October 5, 2010  
NRC3-10-0045

Subject: Detroit Edison Company Response to NRC Request for Additional Information  
Letter No. 31

**Response to RAI Letter No. 31  
(eRAI Tracking No. 4641 Revision 2)**

**Proposed COLA Revisions**

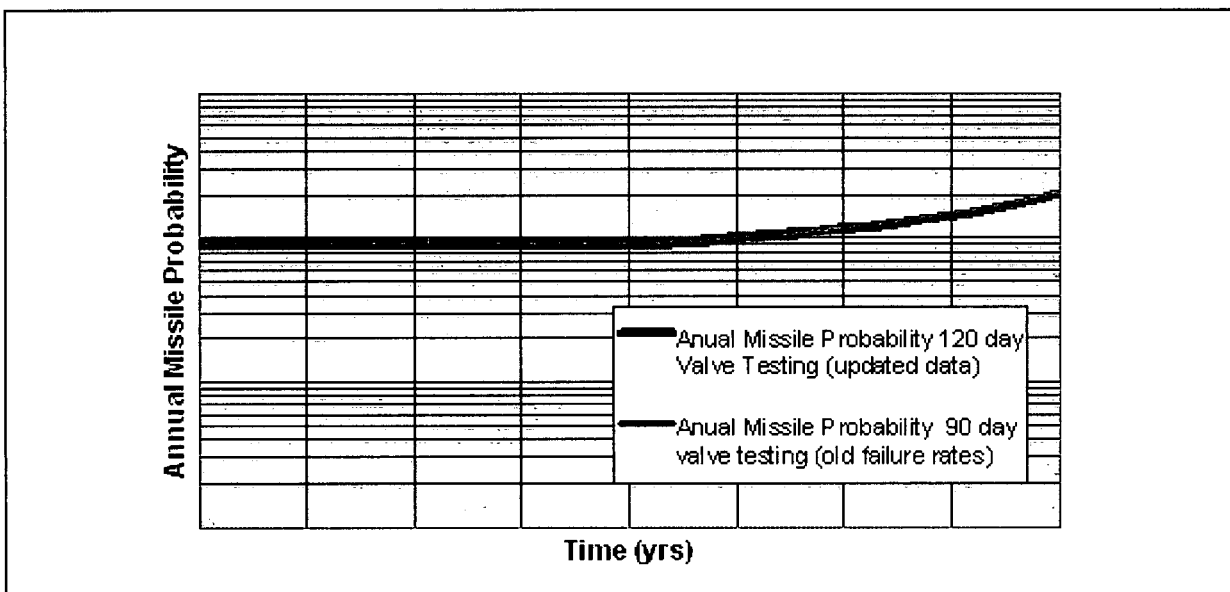
- c. *Section 5.1.2.1 states that approximately the same level of missile probability risk is realized for a valve test frequency of 120-days (with the updated failure rates) versus a 90- day test interval with the older failure rates. Substantiate this statement by providing calculated missile probabilities based on different test frequencies. What is the percentage of the updated failure rates that are associated with turbine units with a valve test frequency of 120-days?*

The following graph provides the comparison of annual missile probabilities for the 120-day valve test intervals using the updated valve failure data vs. the 90-day valve test intervals using the original 1984 valve failure data. By comparison of the analysis results, the data shows no considerable difference in the missile probability risk for the two test frequencies. The percentage of the updated failure rates that are associated with a valve test frequency of 120 days cannot be determined at this time as there is no data that has been collected with this longer test frequency interval. Assessment of the valve failure data indicates that there are no factors that would prevent the extrapolation of the data to the longer test frequency interval and when assessed against the missile probability analysis the risk resulting from the longer test frequency was considered conservative.
